Re: Plugging Permit Applications for API #'s 47-033-05993 and 47-033-05994

RE: Response to Email Dated 9/2/2025 Regarding the 4703305993 and 4703305993

Monday, September 15, 2025
WELL WORK PLUGGING PERMIT
Vertical Plugging

Re: Permit approval for 033-71584
47-033-05993-00-00

Well Plugging Map

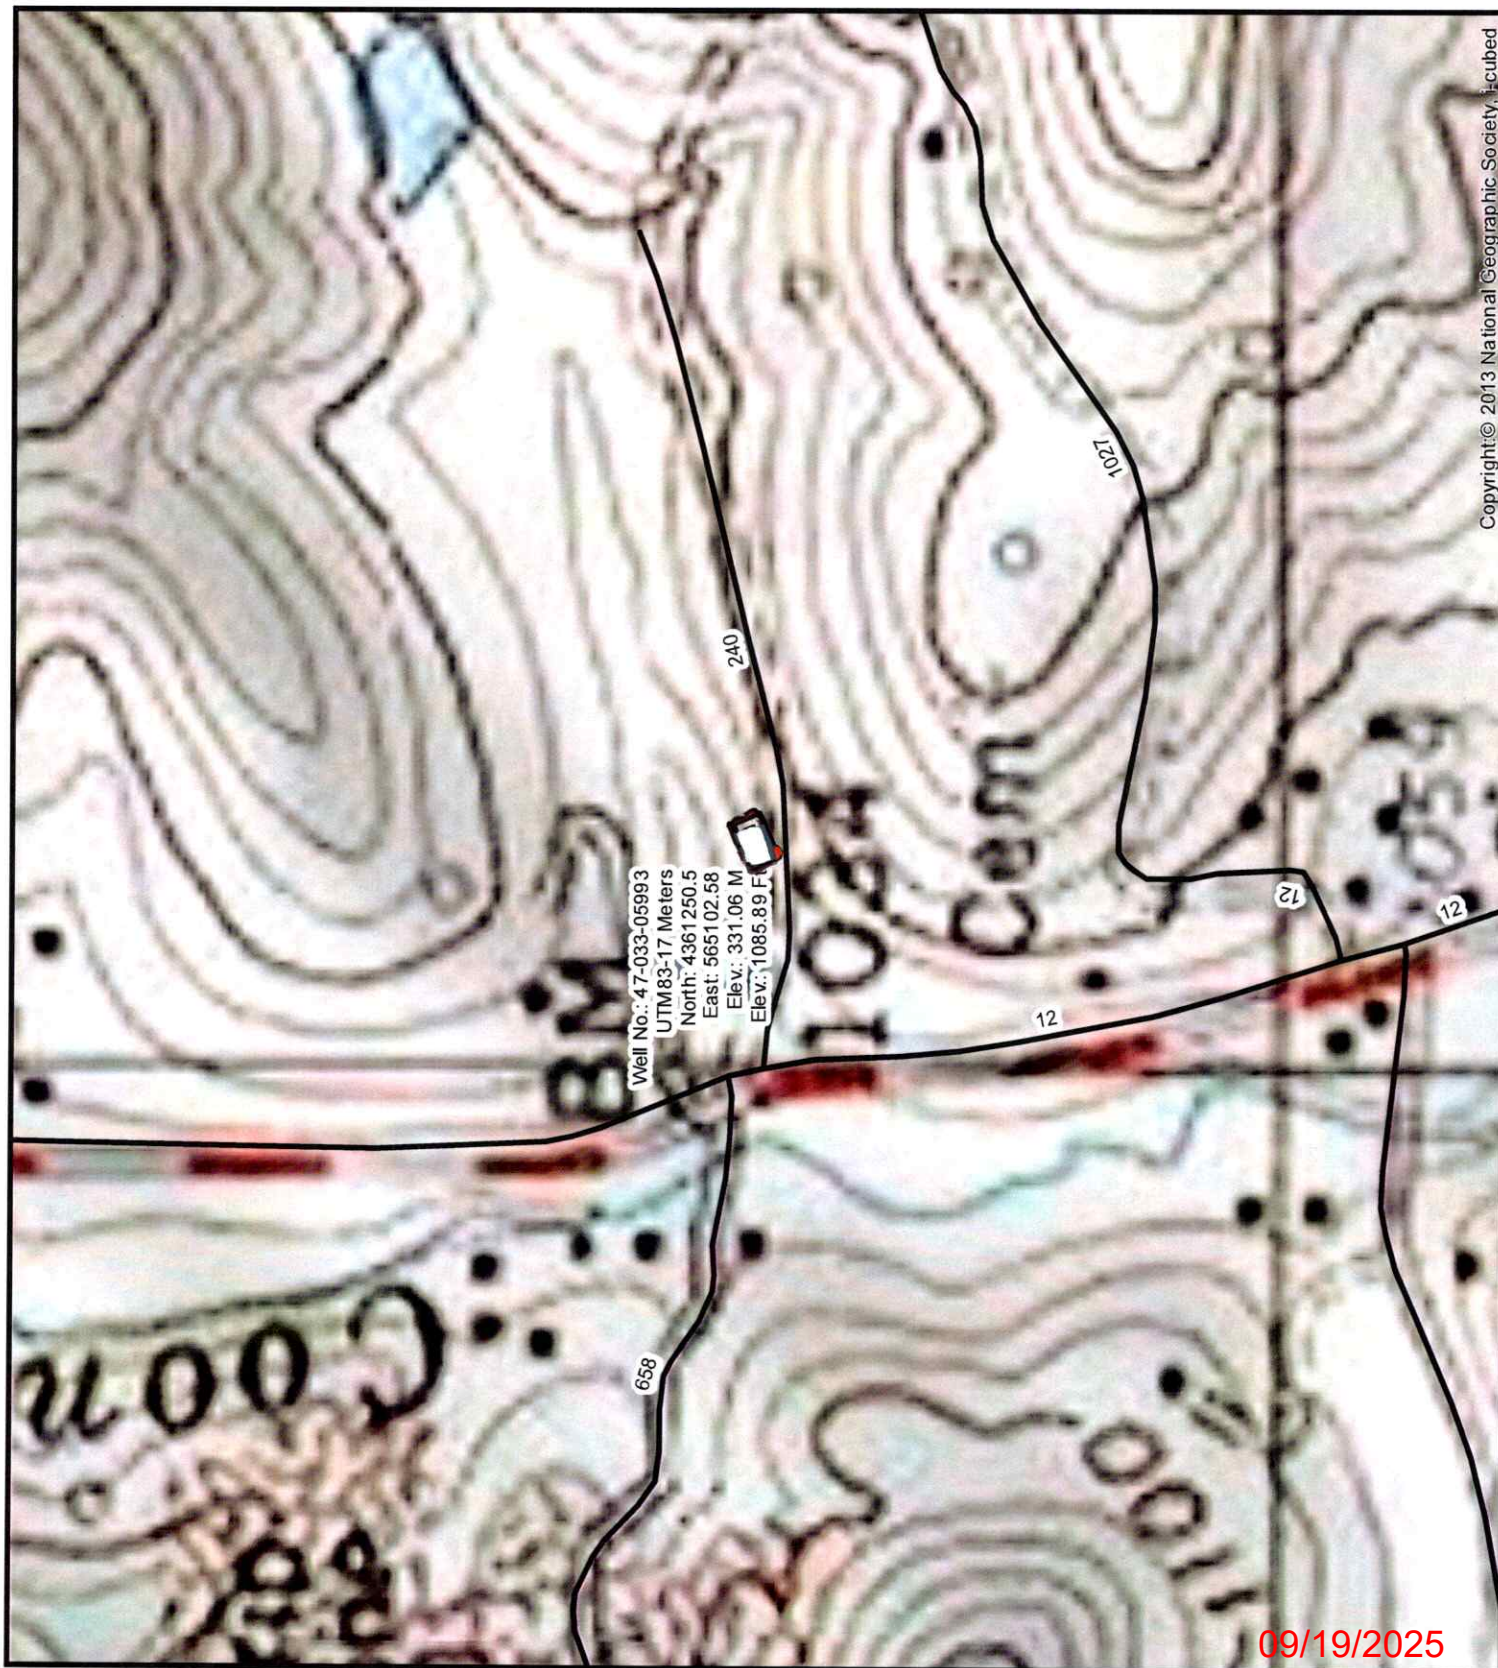
Starting with well 5993. The main concern I would have there is that our water and gas lines are under the proposed Primary and Secondary pit locations. In case any digging would be necessary, our lines could be disturbed. With the pits moved closer to the driveway, this would remove that possibility.

- Earth pits are proposed as a precaution and are unlikely to be needed. If required, they will be placed to avoid existing lines. Any accidental damage will be repaired promptly.

- We will contact 811 to locate underground utilities within the proposed disturbance area and request an onsite meeting with the surface owner to ensure all lines are identified.
